# SPECIAL USE REPORT

▶ **FILE #:** 11-E-21-SU

▶ **PROPOSED USE:** Expansion of an existing church

# A Proposed Renovation & New Building for: Redeemer Church

Main Level Floor Plan - Campus

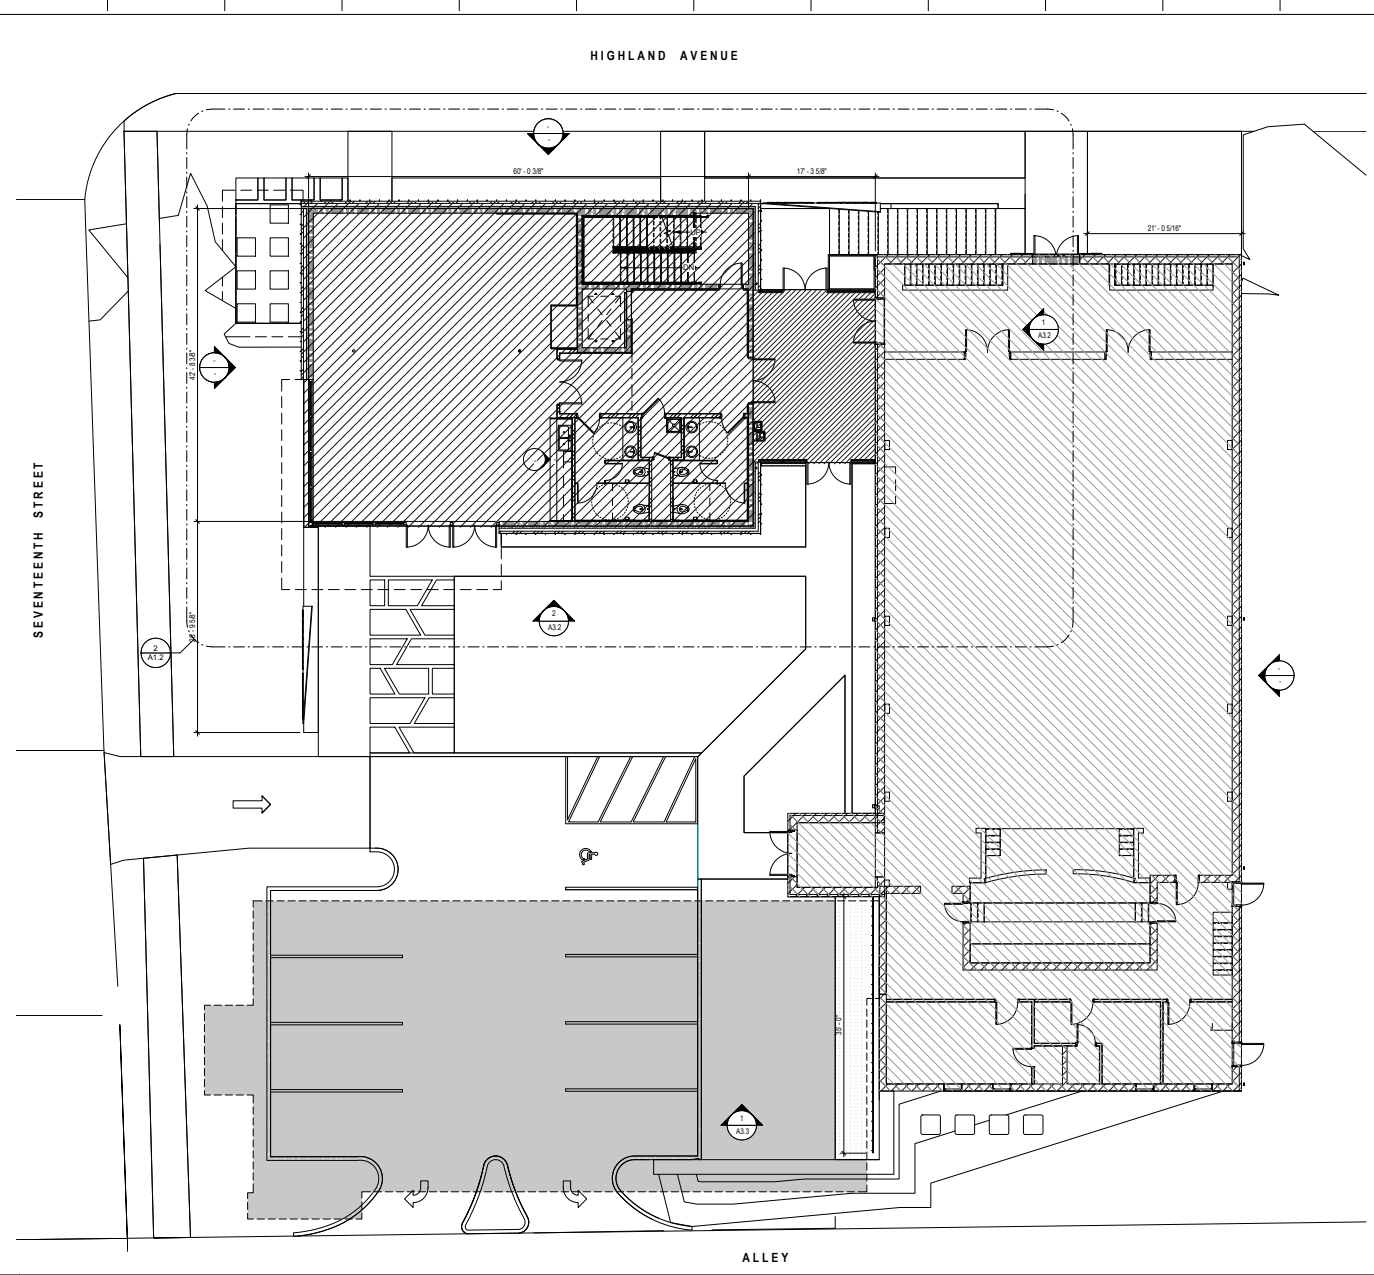
This proposal includes the demolition of an existing 2-story wing of the church that is located at the rear of the property, adjacent to the alley, and the construction of a new 3-story wing that is located along the Highland Avenue frontage. The parking lot will be relocated to the rear of the new building and will have access to S. Seventeenth Street and the alley. The existing parking lot has access to S. Seventeenth Street and Highland Avenue. The S. Seventeenth Street driveway is located opposite of Highland Avenue where there is an existing traffic signal.

B. The parking lot will be located to the rear of the building and will only have access to S. Seventeenth Street via the controlled intersection at Highland Avenue and the alley. The Highland Avenue access will be removed which will remove conflict points along that frontage and potentially allow for additional on-street parking.

1. Meeting all applicable requirements of the City of Knoxville Zoning Ordinance or obtaining the necessary variances from the Board of Zoning Appeals, including but not limited to Article 10.3.T. (Mechanical Equipment), Article 13 (Signs), and the building height.
2. Meeting all applicable requirements of the City of Knoxville Department of Engineering.
3. Meeting the requirements of the certificate of appropriateness approved by the Historic Zoning Commission.

Job Number: 19070  
Roof Plan - Campus

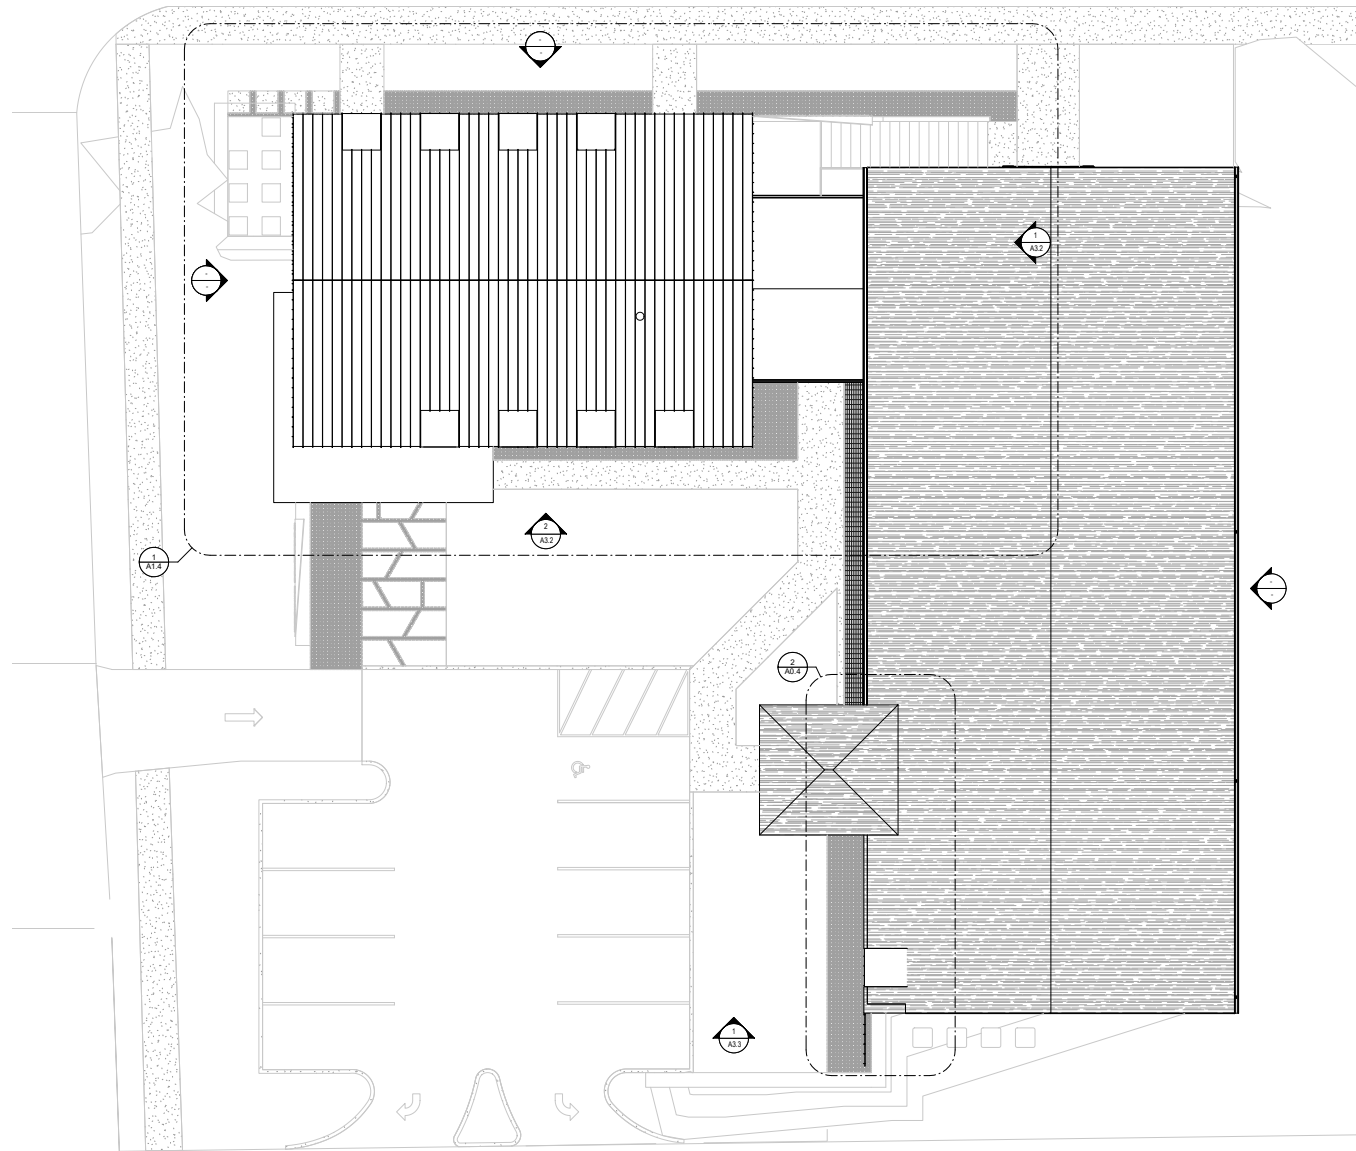
The Historic Zoning Commission approved the addition and site plan as proposed, except for requiring the HVAC mechanical equipment to be moved away from the corner of the building at the Highland Drive and S. Seventeenth Street intersection. If the BZA variance is approved to allow the HVAC units in the proposed location, a new approval by the Historic Zoning Commission will be required.
